Witheyhedge Landfill Site

Leachate Recirculation System

Addendum to the Gas Management Plan

Document No. AGMP/WH November 2016

Gassim Lite – “Wet” Conditions – Recirculation Cell

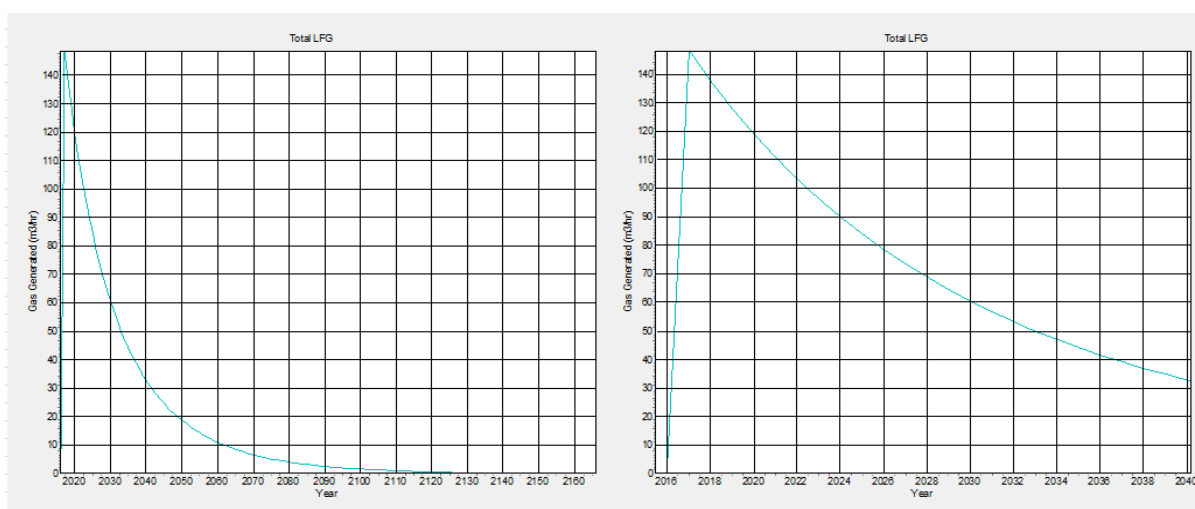
To assess that the gas collection system is able to collect all of the gas that **might** be produced in the recirculation cell, a simple GasSim Lite model has been developed. The model assumes the waste has already decayed to a degree before waste dried out. It has also been assumed that 50% of the waste in the cell still has gas production potential. The impact of recirculation assumes in the first scenario that the waste will become “wet” in the model 216,000 cubic metres (the model uses 259,000 tonnes based on a compaction ratio 1.2 t/m³) of waste are in the cell that is to be recirculated into. The Gassim Lite production curve (50 percentile) can be seen under these conditions. The maximum gas production rate is predicted in 2017 and is 370m³/hour. This is considered to be conservative estimate of potential uplift. At 85% collection rate we would expect to see 314m³/hour landfill gas collected.
